SUBJECT: COMANCHE PEAK NUCLEAR POWER PLANT, UNITS 3 AND 4
DOCKET NUMBERS 52-034 AND 52-035
RESPONSE TO REQUESTS FOR ADDITIONAL INFORMATION
NO. 2748, 2764, 2843, 2844, 2875, AND 3400

Response to Request for Additional Information No. 2748 (CP RAI #35)

RAI NO.: 2748 (CP RAI #35)

SRP SECTION: 11.03 – GASEOUS WASTE MANAGEMENT SYSTEM

Figure 11.3-201 Gaseous Waste Management System Piping and Instrumentation Diagram (Sheet 3 of 3)

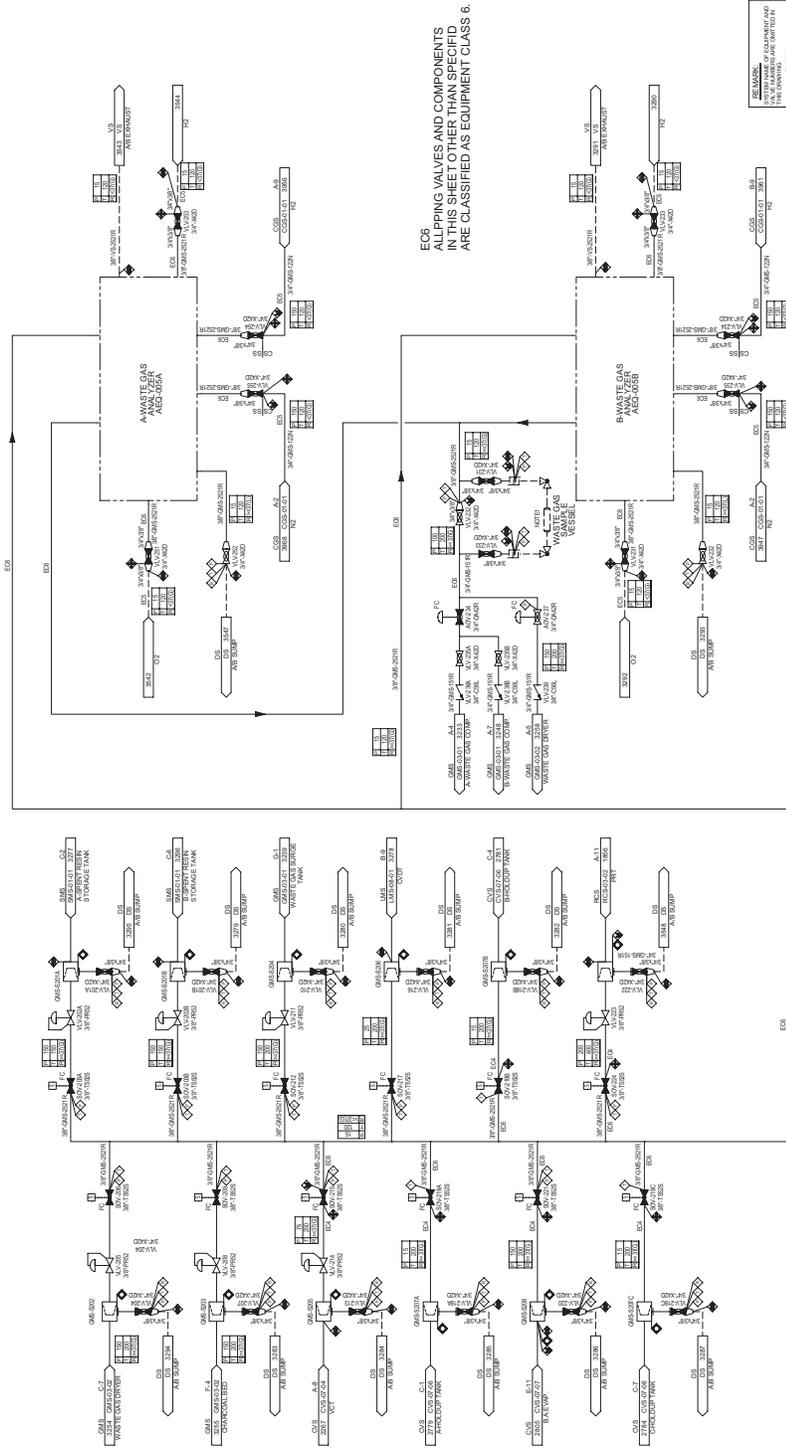
Regulatory Position 2.3 of Regulatory Guide 1.143, "Design Guidance for Radioactive Waste Management Systems, Structures, and Components Installed in Light-Water-Cooled Nuclear Power Plants," Revision 2, November 2001, states, "The portions of the gaseous radwaste treatment system that are intended to store or delay the release of gaseous radioactive waste, including portions of structures housing these systems, should be classified as described in Regulatory Position 5 and designed in accordance with Regulatory Position 6." Luminant is requested to explain why Combined License Application, FSAR Figure 11.3-201 Sheet 3 does not include the same note as Sheets 2 and 3, which states, "All piping valves and components in this sheet other than specified are classified as equipment class 6."

The note contained in FSAR Figure 11.3-201 Sheets 1 and 2, which states, "All piping valves and components in this sheet other than specified are classified as equipment class 6," has been added to Sheet 3.

EOS
 ALL PIPING VALVES AND COMPONENTS
 IN THIS SHEET OTHER THAN SPECIFIC
 ARE CLASSIFIED AS EQUIPMENT CLASS 6.
